Date	Number	Page
2/17/11	<b>RVXX1006</b>	1(3)

**Inversion Valve, Fifth Wheel Air  
Release****VNM, VNL****RVXX1006, Inversion Valve, Fifth Wheel Air Release**

**Figure 1 — Position exhaust flapper in a downward plane.**

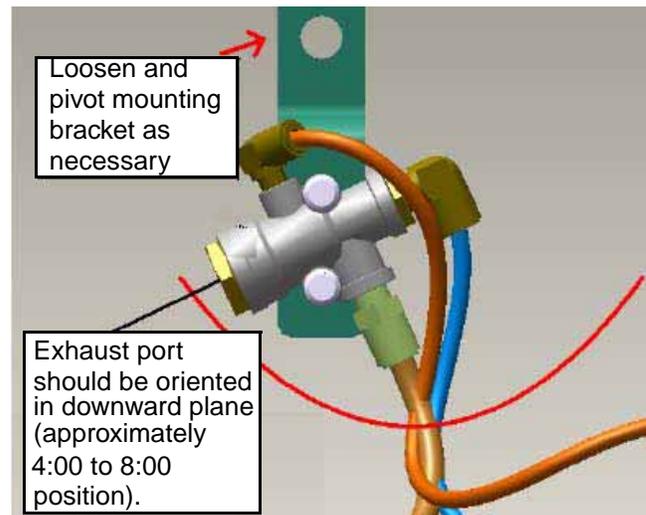
The inversion valve on the frame may be orientated where contaminants can enter the valve through the exhaust port. If this occurs, corrosion may occur, which can cause the valve to malfunction and in extreme cases possibly result in unintended opening of the fifth wheel's locking mechanism that holds the trailer's king pin.

1. Visually inspect the TR-3 inversion valve for proper orientation (i.e. 4-8 o'clock position). If the orientation results in the exhaust port being outside of the 4-8 o'clock position, replace the valve with Volvo part number 8084521 (Bendix part number 281459N) (see Figure 1). All valves must be purchased from a Volvo dealer. Make certain that the existing or replacement valve is installed inside the frame rail with the exhaust facing in a downward plane (see figure #3 photo). It may be necessary to remove and reposition the mounting bracket to ensure the TR3 inversion valve exhaust is facing in a downward plane. Use a grade 8 bolt and lock nut of the proper length to secure mounting bracket to frame. Torque to 140 +/- 24 Nm (103 +/- 18 ft-lb).

The repair consists of performing a visual inspection of the TR-3 inversion valve in the TouchLoc 5th wheel control system to see if the exhaust port is pointed down (i.e. 4 to 8 o'clock), and replacement if it is not pointed down (i.e. 4 to 8 o'clock).
